County of Santa Clara

STAFF REPORT
Zoning Administration
November 4, 2021

File: PLN20-124

Design Review Approval (Tier 2) and Grading Approval for a New Single-Family Residence

RESIDENCE
EXTERIOR ELEVATIONS

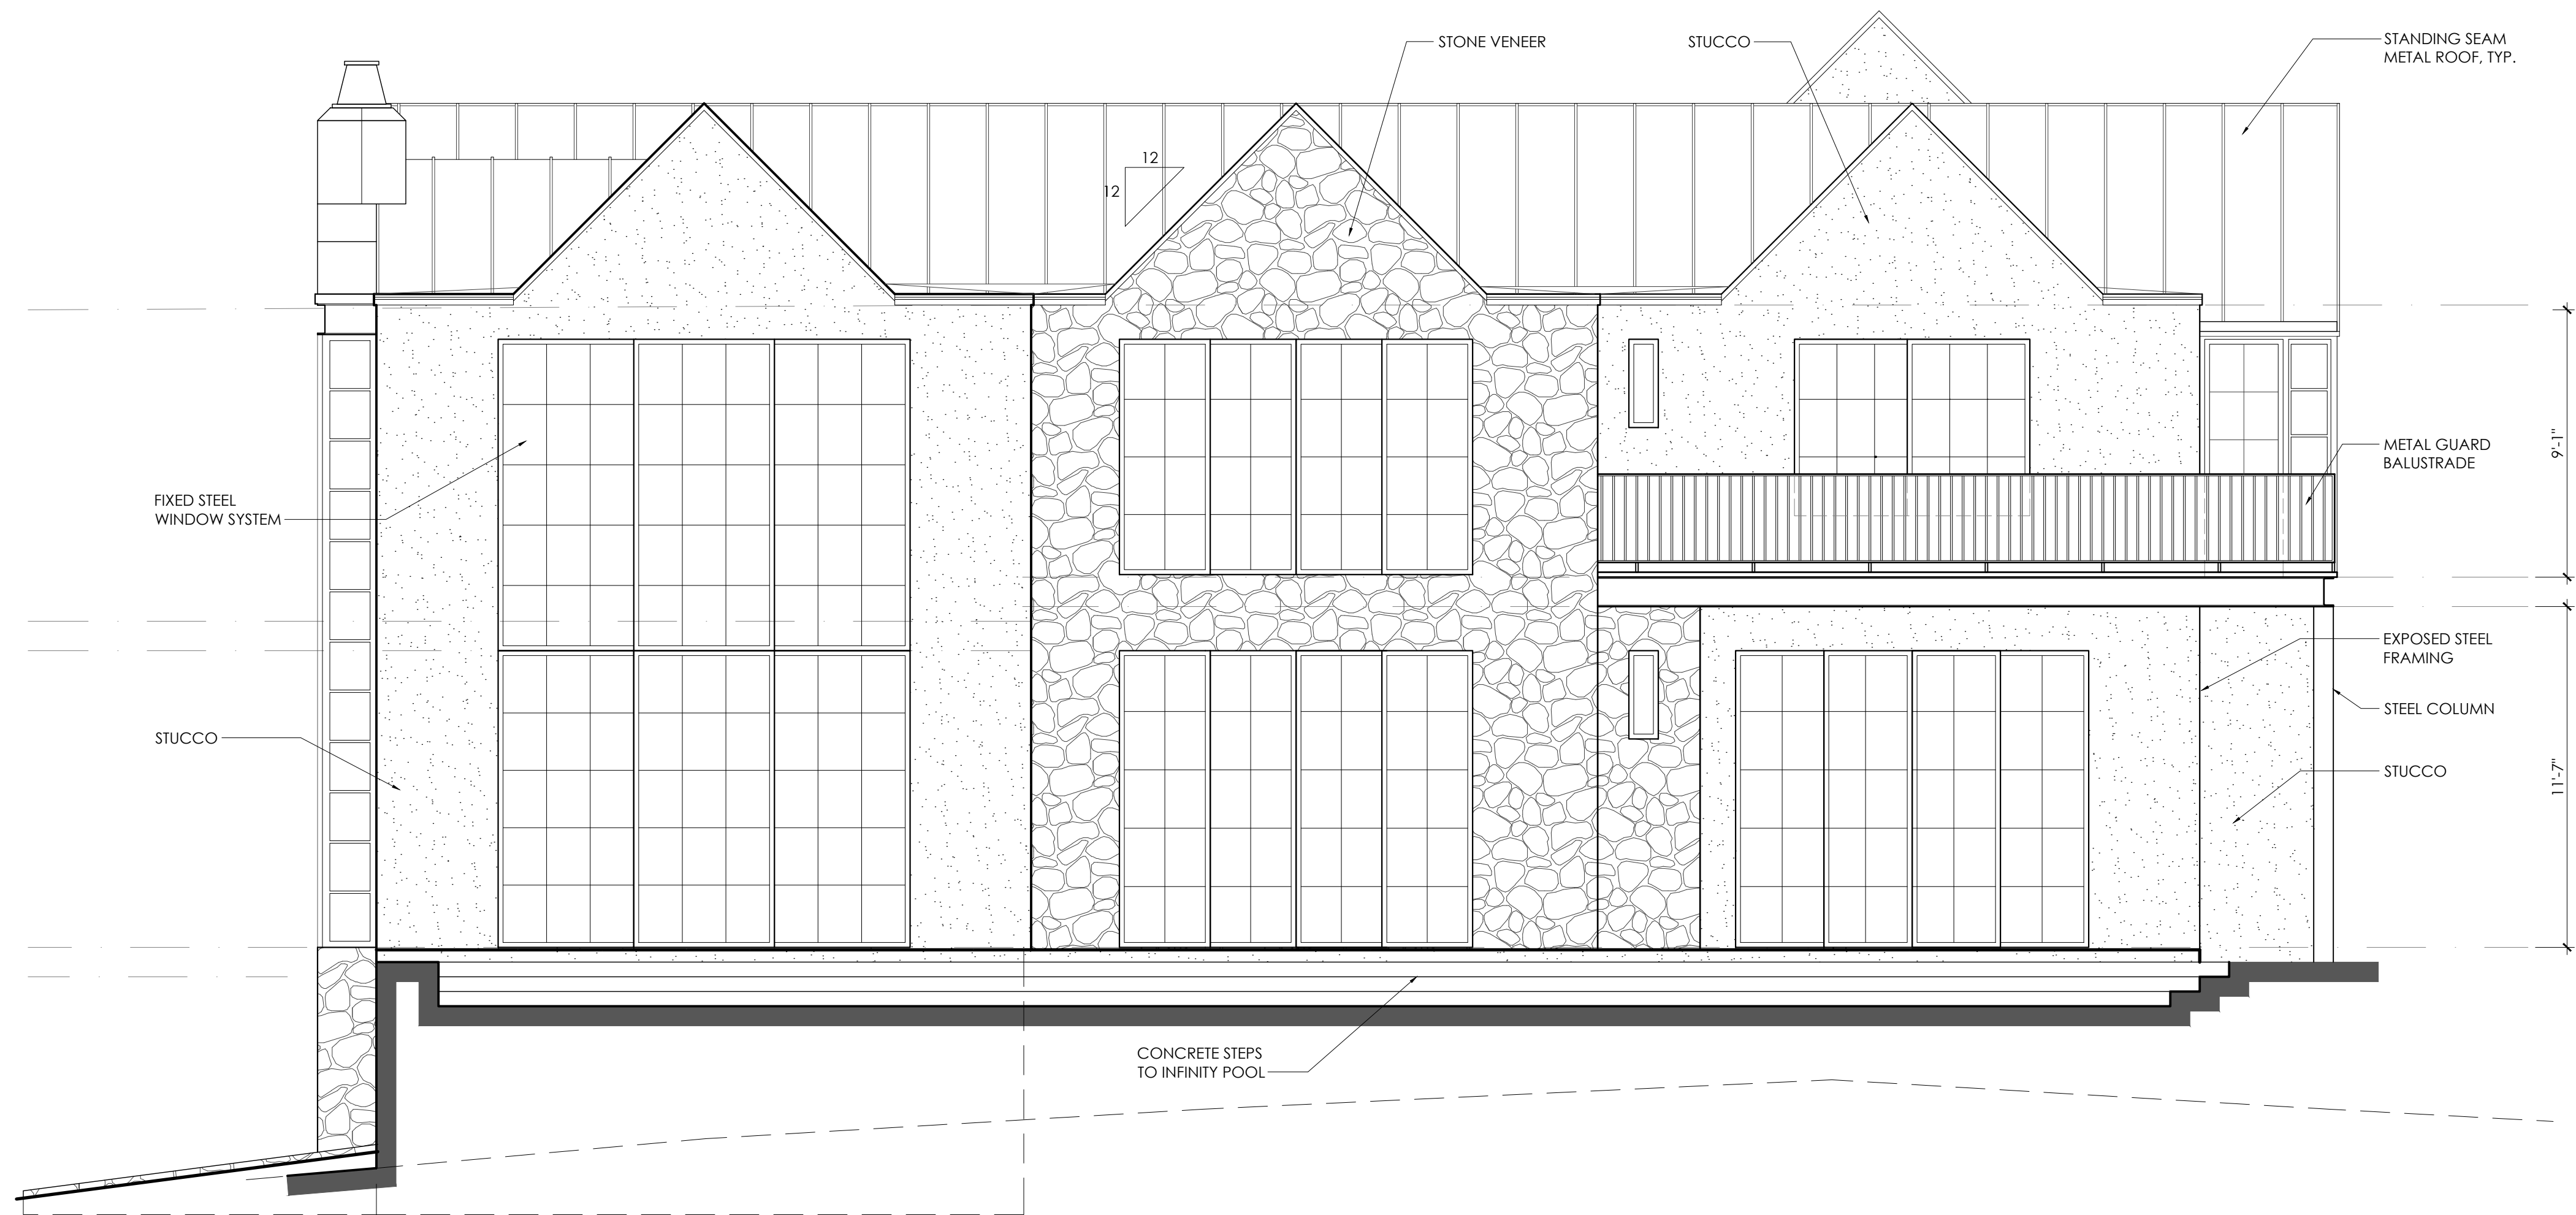
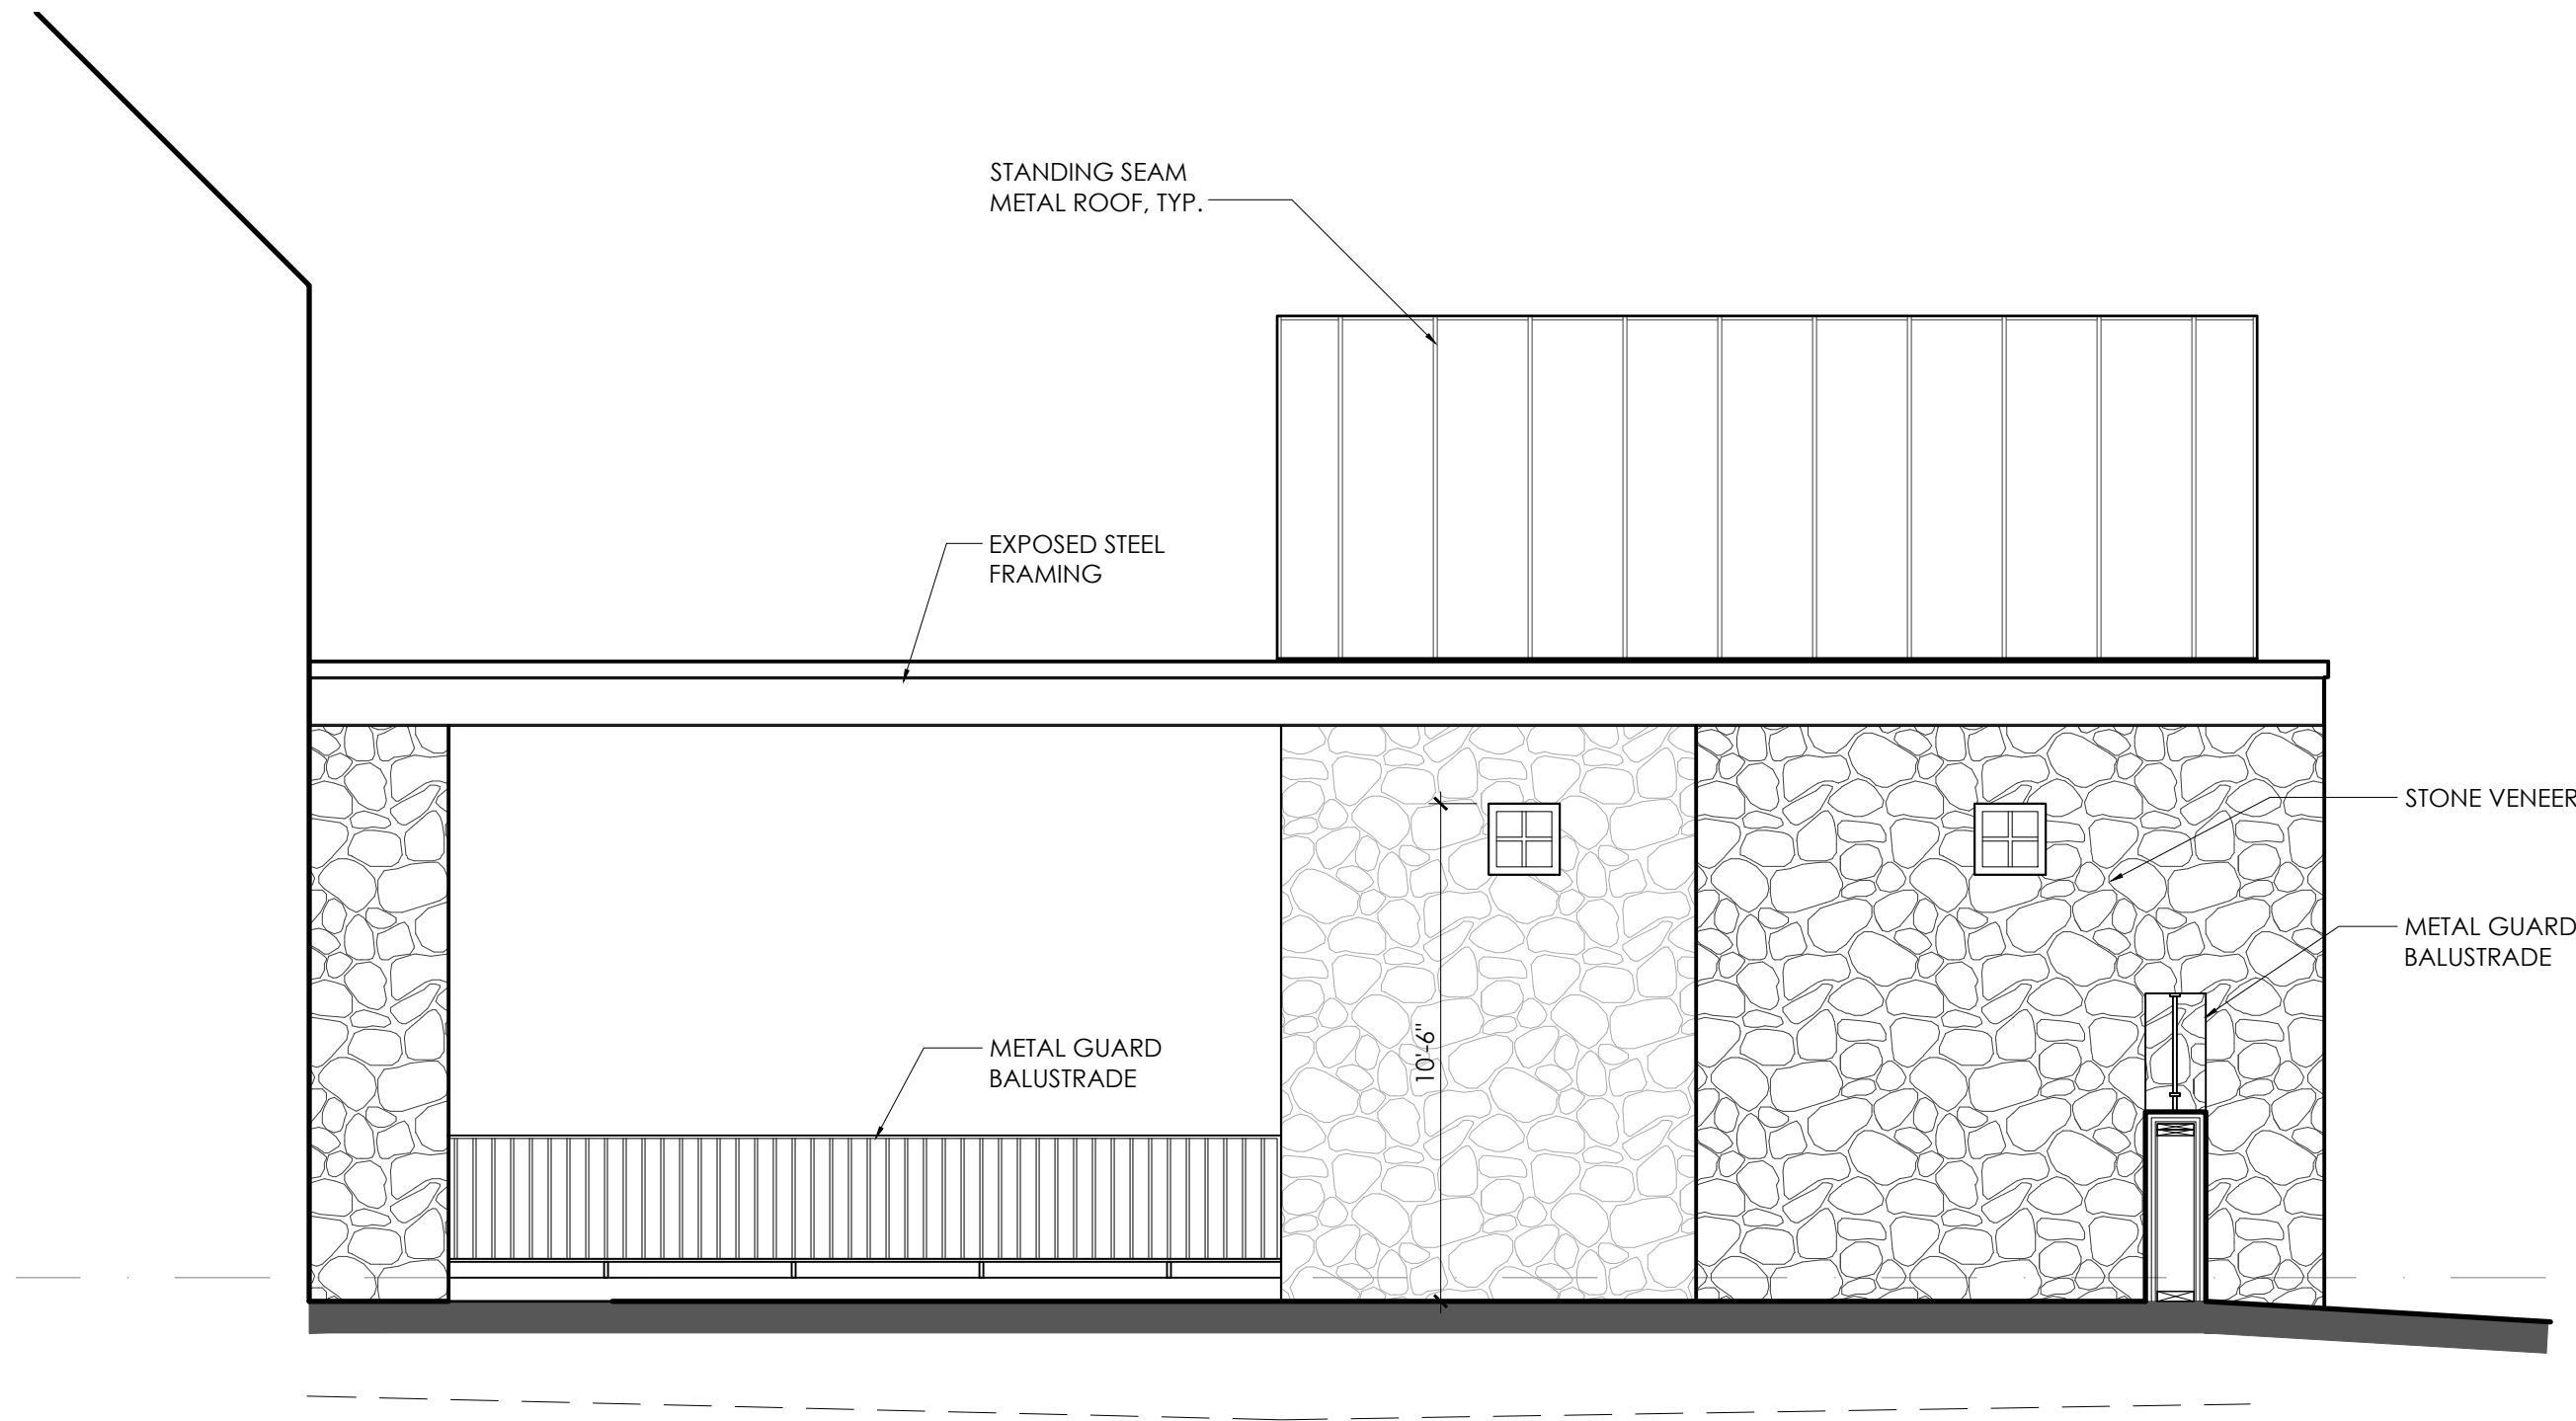
The submitted North and South elevations identify two (2) continuous wall planes with a horizontal length of more than eighty (80) feet. The south, east, and west facades are proposed with continuous architectural components that exceed eighteen (18) horizontal feet and 24 vertical feet. On the south elevation, one expansive wall plane has a maximum wall height of 29 feet and a continuous wall length of 65 feet (Attachment G). These wall planes are considered ‘continuous’ because no portion of the wall is offset by at least five (5) horizontal feet to be deemed ‘discontinuous’ pursuant to Zoning Ordinance §3.20.040(C)(3).
